**Re: Technical Revision (TR-8) Request**

Reclamation of Little Deadwood Gulch and Chief Portal  
May Day Idaho Mine Complex  
Permit No. M-1981-185  
112d-1 Reclamation Permit  
Board Order Signed-March 3, 2016

The following is Wildcat Mining Corporation (Wildcat) technical Revision (TR-8)<sup>1</sup> requesting approval of the proposed Little Deadwood Gulch drainage modification to the April 1, 2013 approved remedial plan (TR-5). The original drainage plan was designed by Carroll & Lange-Manhard (Manhard) and submitted to the Division on March 18, 2013.

Figure 1  
24 inch CMP and 4-6 inch sub drain Installation Alignment  
Chief-Little Deadwood Gulch Drainage

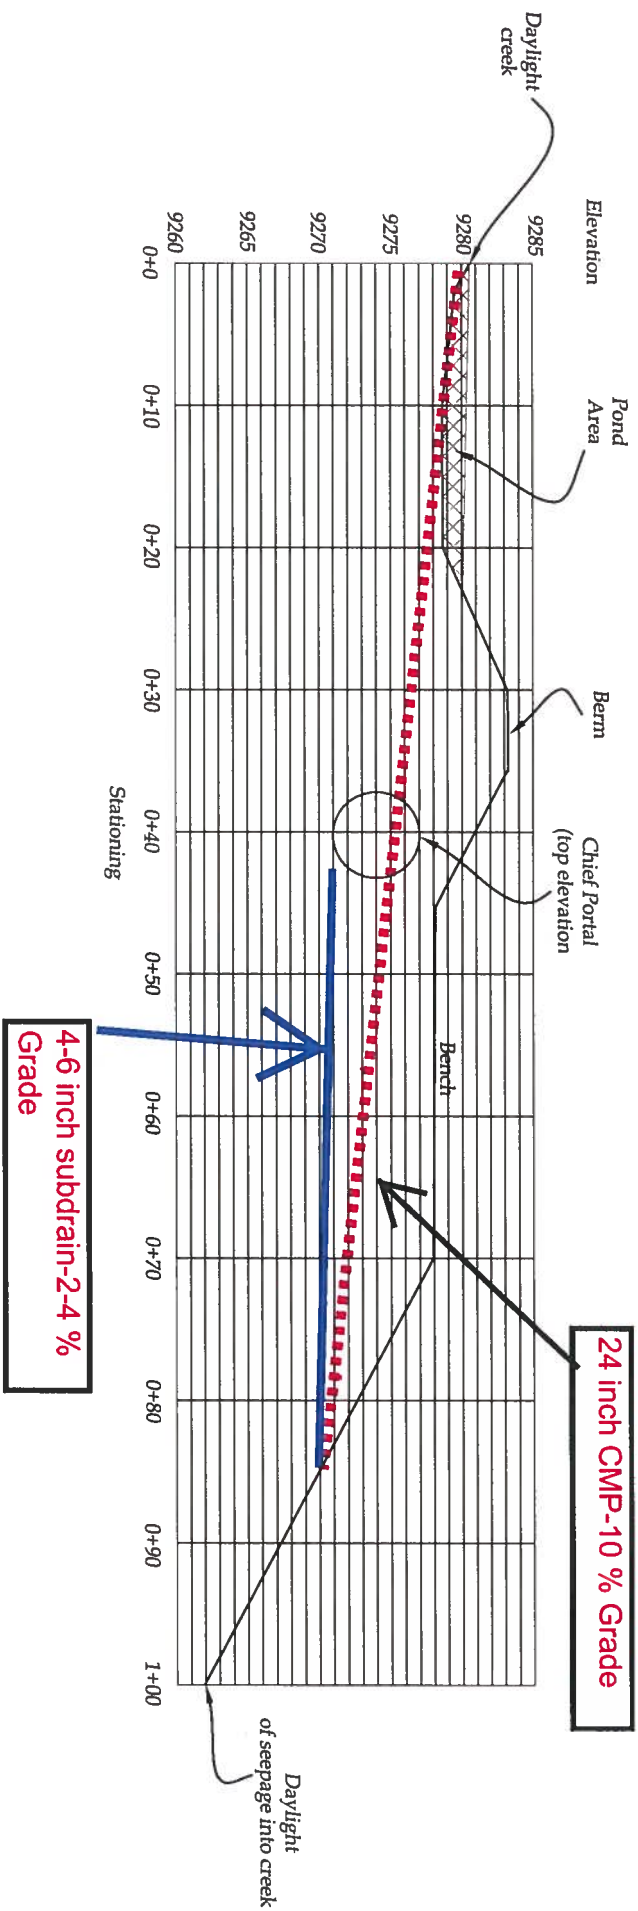
4. Because the manway (portal) depth exceeded original design depth estimates, Wildcat proposes to install the 24 inch culvert in LDG to a depth approximately 2 to 7 feet at average grade of 10 percent. (See Figure 1 and 2) The 24 inch culvert will convey upgradient water (10year 24 hour storm) through the fill.

5. Water discharged from the 24 inch pipe will be installed approximately 7 feet below the down gradient fill crest of the alluvium. Riprap (D50-12 inch) will be installed at the discharge point to control erosion.

**Figure 3**  
**Little Deadwood Gulch Drainage Conceptual Plan View Illustration**

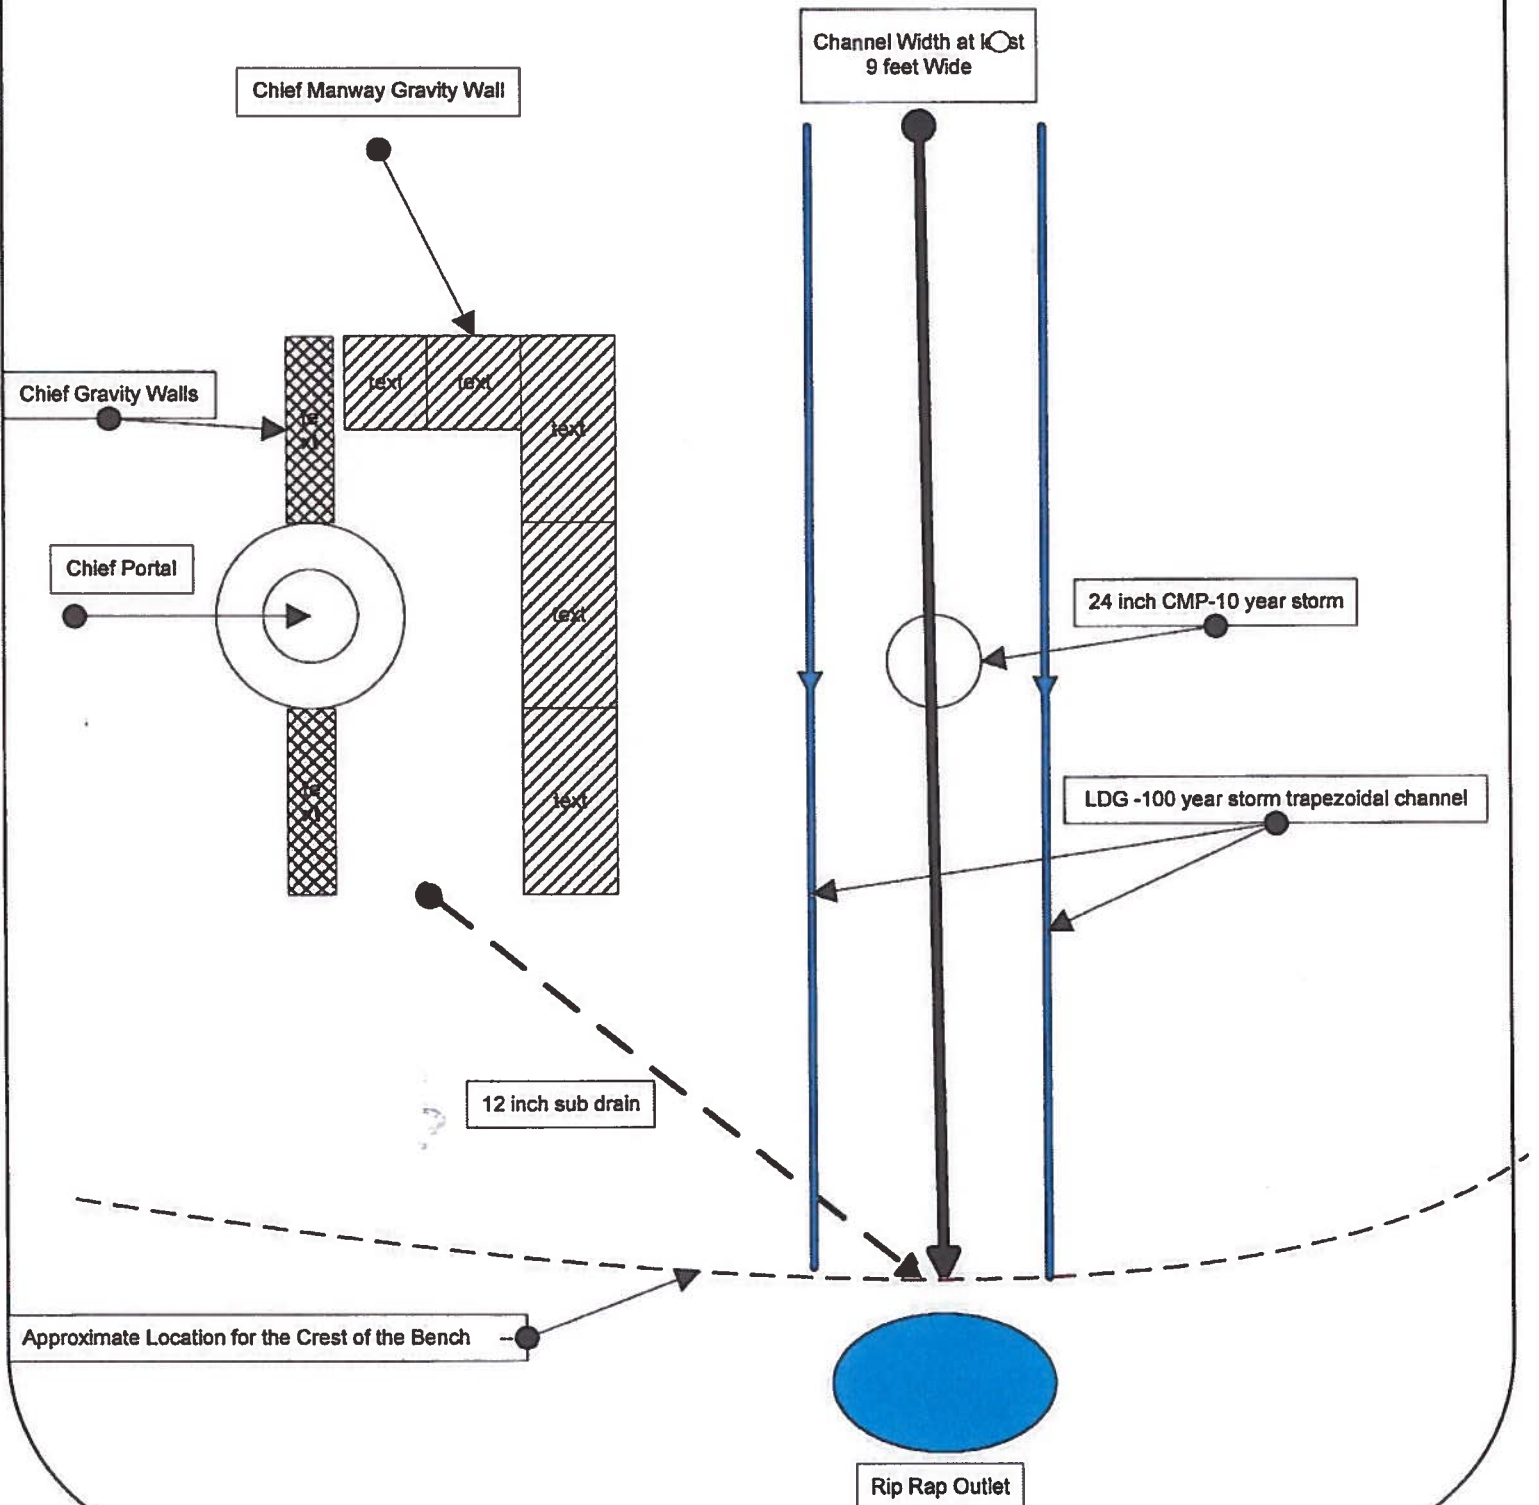
6. Alter the TR-05 culvert alignment to the east approximately 10 feet (away from the 66 inch manway entrance) to accommodate the installation of gravity blocks (Photo 1) in front of the manway (Figure 3) See Photo 2;

7. To provide stability to LDG alluvial materials outside of the portal manway, gravity blocks will be placed immediately upgradient and parallel to of the manway portal. The upgradient block extension will be approximately 4 feet and approximately 16 feet long to be constructed at an angle of 20-30 degrees away from the manway portal. (See photo 2 and Figure 3). No blocks will be placed on the down gradient side of the 66 inch culvert to allow a ramp to be constructed to permit rescue crews to gain access to the manway.

### Little Deadwood Gulch-Upgradient Drainage Alignment

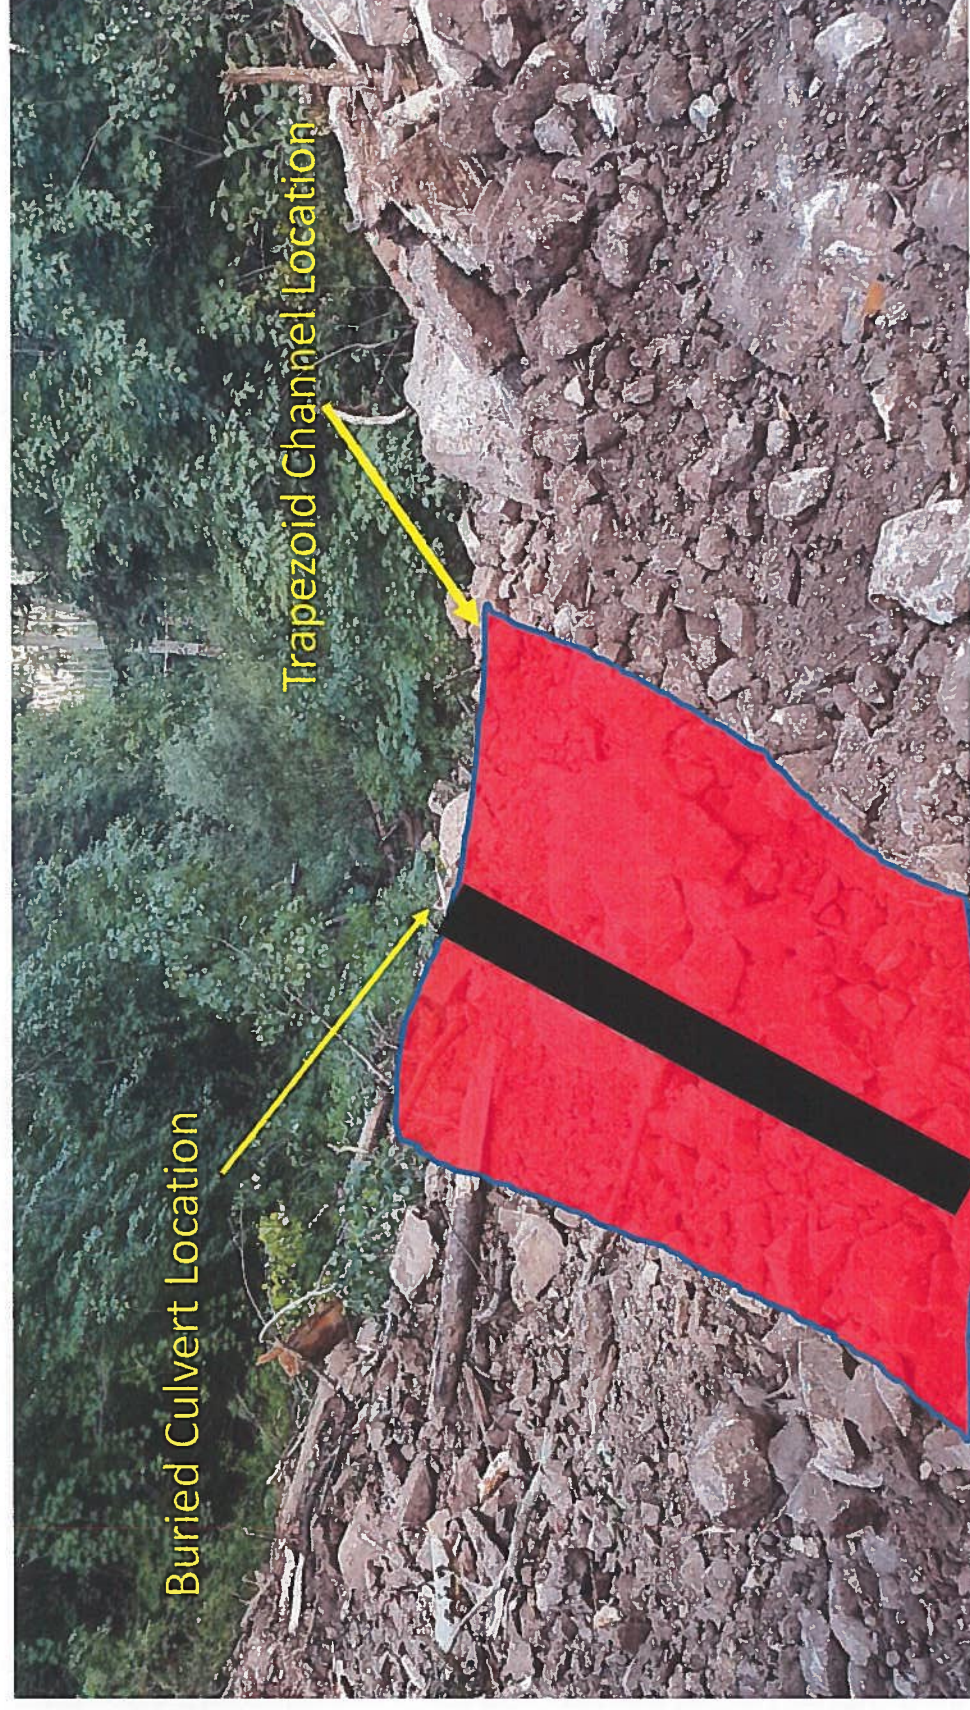
9. A trapezoidal channel (Table 2)) (Photo 3 and 4) will be constructed to convey the 87 cfs peak flow of from the 100 year-24 hour storm (Manhard, 2013). The bottom width will be approximately 9 feet, side slopes 4H:1V, 2 feet deep and with a channel bottom width of 2 feet;
10. The disturbed area will be reclaimed as approved in accordance with TR-5 approved design;
11. BMPs (wattles, silt fences, rip rap) will be installed to stabilize the reclaimed surface and in accordance with the original plan (TR-05-April 1, 2013).
12. Debris and wood will be removed and disposed off-site.
